16 Ormes Lane, Ratcliffe Culey
Proposed Extension & Alterations

Proposed | Floor Plans & Elevations

CLIENT | Mr & Mrs Cartwright
DRAWING NO | 154-PR-200-A
DRAWN | SS
SCALE | 1:50 @ a1
CHECKED | SS

Proposed | Front Elevation

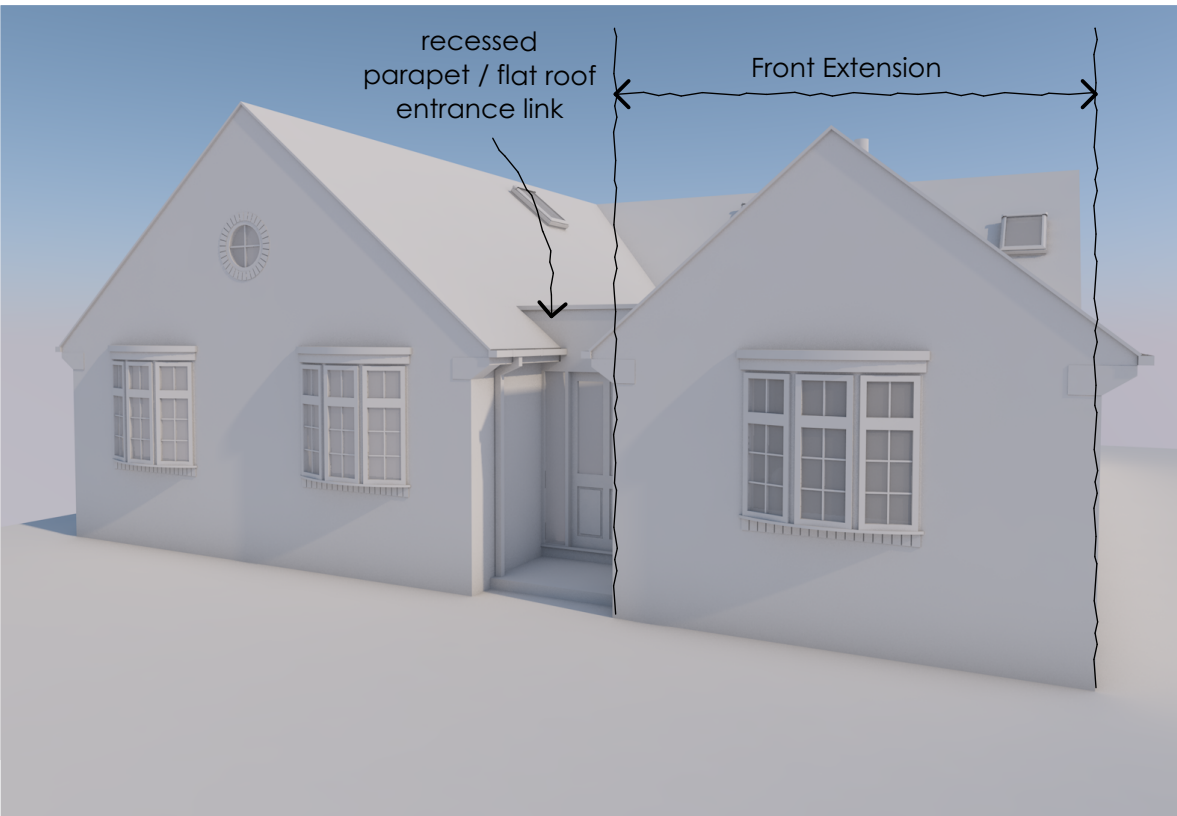
Revision: A
Date: 06.01.26
Details: width of proposed bow window to front elevation revised to match width of existing bow windows
